SUBJECT: ISSUANCE OF AMENDMENT (TAC NO. 79374)

The amendment revises Technical Specification (TS) 3.3 of the Oyster Creek Nuclear Generating Station TS. Specifically, the amendment revises TS Section 3.3.A, pressure/temperature limits of the reactor coolant system for operation up to 17 effective full power years. It also revises TS Section 3.3.B to provide a new reactor vessel temperature limit for full tensioning of the reactor vessel closure head studs.

Amendment No. 151  
License No. DPR-16

SAFETY EVALUATION BY THE OFFICE OF NUCLEAR REACTOR REGULATION

FIGURE 3.3.1  
OYSTER CREEK P/T LIMITS

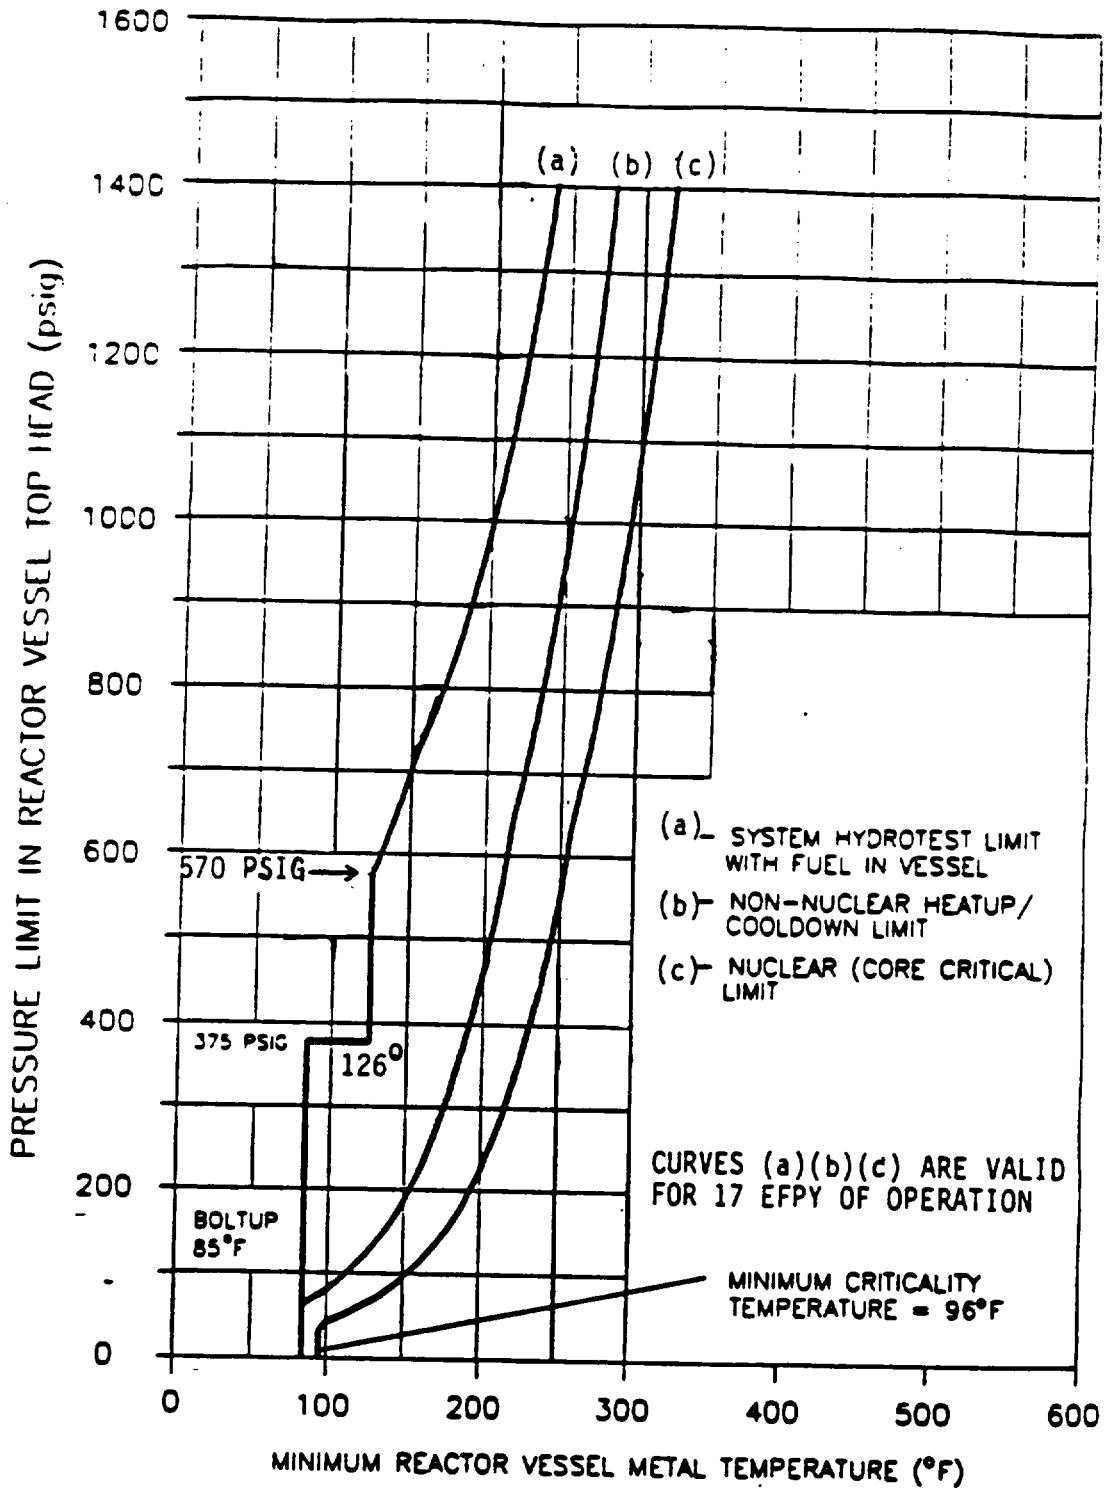
The licensee used the method in RG 1.99, Rev. 2, to calculate an ART of 137.5°F at 1/4T for the same limiting plate metal. Substituting the ART of 137.5°F into equations in SRP 5.3.2, the staff verified that the proposed P/T limits for hydrotest and cooldown meet the SRP 5.3.2; however, the licensee's heatup limits at 1000 psi is about 19°F less conservative than the staff's calculation.

In the normal BWR operation, the reactor coolant system (RCS) is heated based on the thermodynamic saturated steam line which is much more conservative than the P/T limits. Based on this consideration, the staff believes that the 19°F difference is acceptable; therefore, the proposed P/T limits for heatup is also acceptable.

The staff concludes that the proposed P/T limits for the reactor coolant system for heatup, cooldown, leak test, and criticality are valid through 17 EFPY because the limits conform to the requirements of Appendices G and H of 10 CFR Part 50. The proposed limits also satisfies Generic Letter 88-11 because the licensee used the method in RG 1.99, Rev. 2 to calculate the ART. Hence, the proposed P/T limits may be incorporated into the Oyster Creek Technical Specifications.
